# Stage 05: Draft Final Modification Report

### CMP268

## 'Recognition of sharing by Conventional Carbon plant of Not-Shared Year-Round circuits

This document contains the discussion of the Workgroup formed in August 2016, responses to their consultation and the Workgroup's final conclusions.

Figure 4: 2015 Analysis

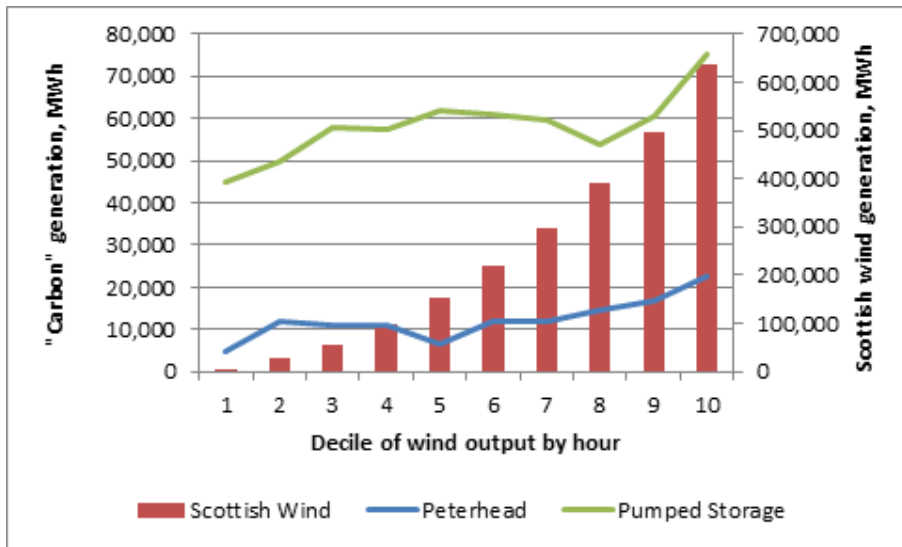
- 4.15 The Workgroup member furnished the Workgroup with a graph of data (Figure 4) from every half hour in 2015 that they believe bears out this supposition, as well as circulating the underlying data/spreadsheet. They noted that by bundling the generation data points into deciles by wind output, what appears to be the very relationship that was conjectured is seen. They used data for the metered data from a representative sample of 6 Scottish generators (as visible in central systems), namely Areleoch, Blacklaw, Harestanes, Clyde, Griffin, and Hadyard Hill, choosing this area as they considered it to be the most marked case of an export-constrained area with more than half renewable capacity. They also noted that in the windiest 10% of hours (Decile 10, the right-most bar below), the output from the Scottish pumped storage stations (green) and Peterhead (blue) are both significantly higher than in the least windy 10% of hours, indeed higher than in any other decile in-between”. The analysis was not extended due to lack of time to other areas with

relevant conventional carbon assets and a non-zero non-shared generation TNUoS charge elements such as the Northern English TNUoS charging zones down to zone 15, or zone 22.

### CMP268 - 25% ALF

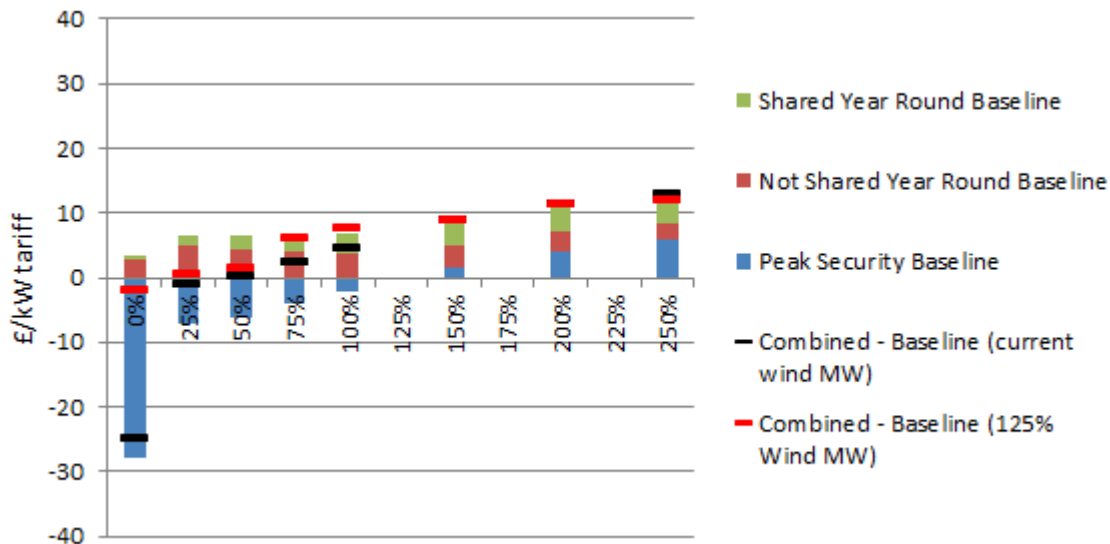
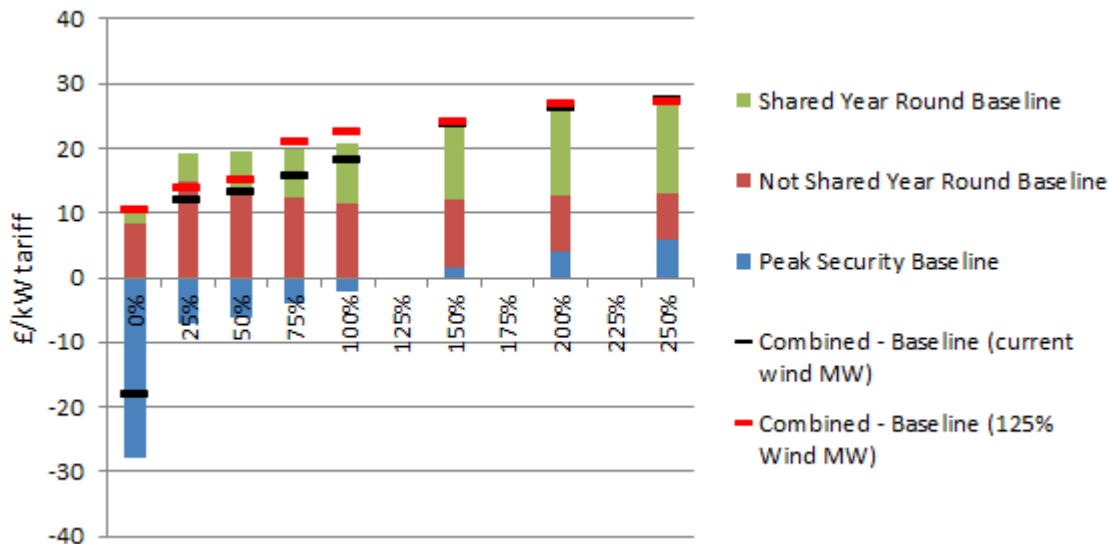
- 4.99 A Workgroup member stated that the graphs above do not show any instability, but simply show that the cost drivers on this part of the network are more complex. The Workgroup member considered that in this area of the network you have a lack of diversity which is pulling the cost in one direction to one equilibrium and the effect on north south flows on the rest of the network which is pulling the charge in another direction to another equilibrium. The direction the overall charge goes in response to an investment decision depends on which driver has the dominant effect under those set of circumstances. He went onto state that the locational signals are consistent with what you would expect to see and that this is simply the nature of how complex the factors are which determine the cost of the network and are reflected in the charging model. He went on to state that this is no different to what happens elsewhere in the methodology. For example a station in the south with very low tariffs will have some circuit costs which are negative and some which are positive. A change in its flows may increase costs in some circuits and decrease costs in others in the model. The effect on charges depends on which effect is the greater. Another Workgroup member felt that the graphs provided did not illustrate anything to support CMP268.

**Figure 1: Difference from SQSS factor scaled YR charges, of charges calculated using Existing Methodology and CMP268**

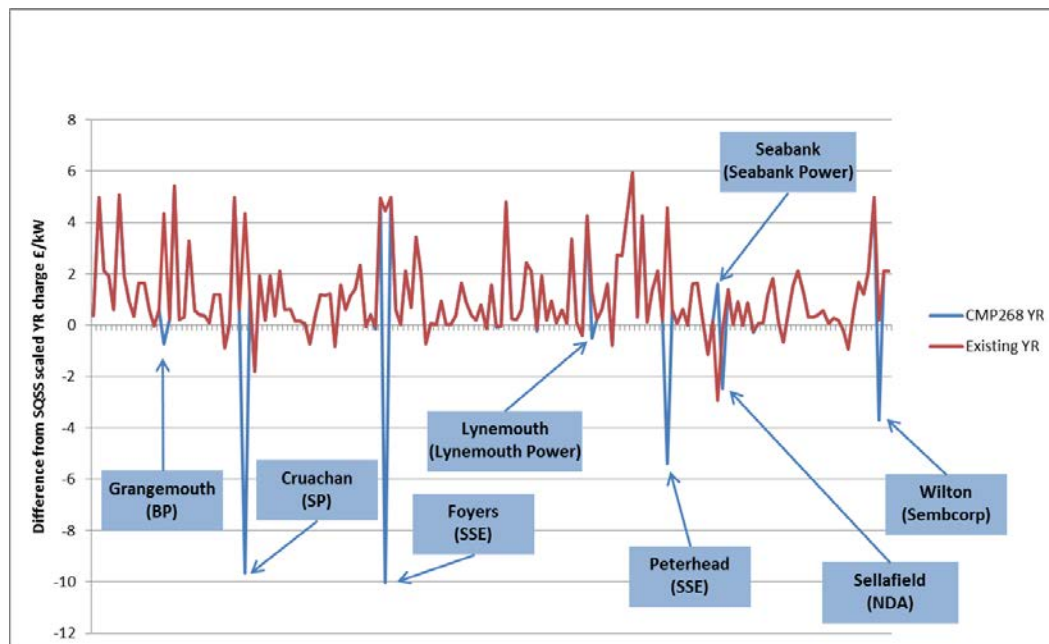
What figure 1 shows is that the existing methodology tends to produce Year Round charges which are not the same as those using the SQSS factors. Of course, this is not surprising given that the SQSS uses a generation class average and the ALF is

**Figure 2: Difference from SQSS factor scaled total charges, of charges calculated using Existing Methodology and CMP268**

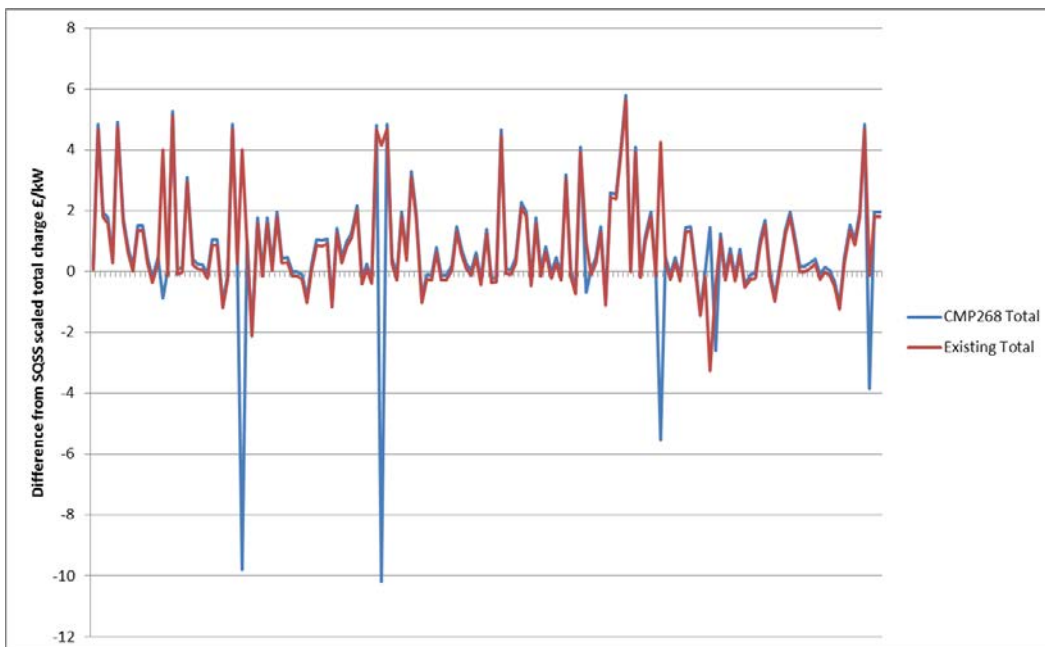
Figure 2 is essentially very similar to figure 1. However, what it does show is that in order to pay for the large reduction in charges for a few stations provided under CMP268, the charges for all other stations are increased slightly, generally moving them even further away from those values calculated using the SQSS scaling.

**Figure 4: Total TNUoS tariff stacks for existing methodology and CMP268**

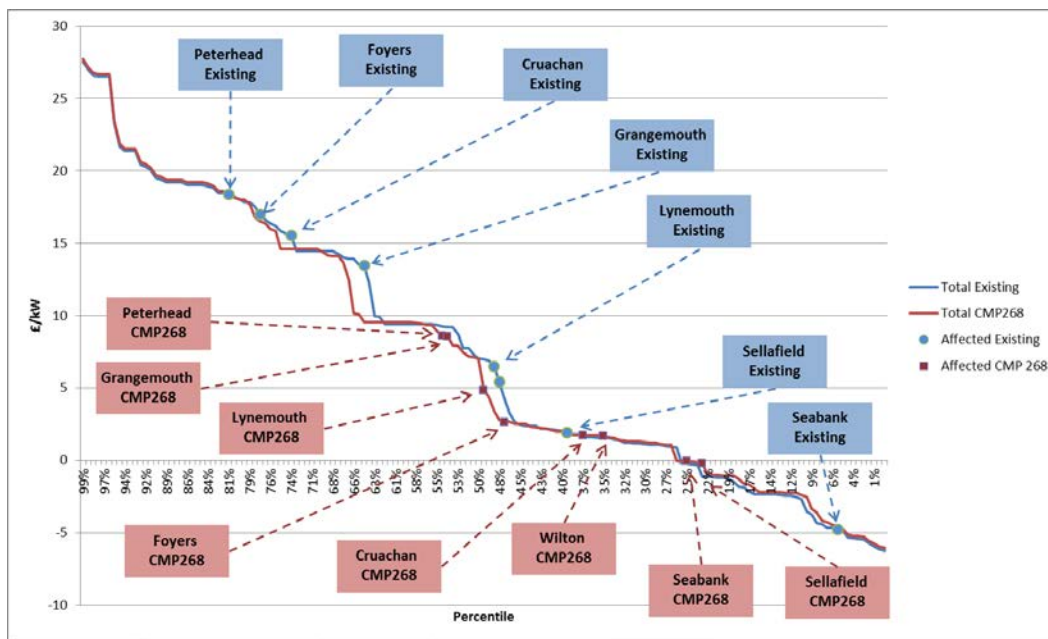
We have tested this theory as we considered that a £9.95 reduction in charges couldn’t possibly occur without that station moving down the rankings on the level of £/kW charge it is exposed to. We therefore sorted the charges calculated under CMP268 and the existing baseline from highest to lowest, and plotted the resulting profile. This is shown in figure 4. As well as showing the two stacks we have also plotted where the stations that are principally affected by CMP268 would sit on each of the stacks.
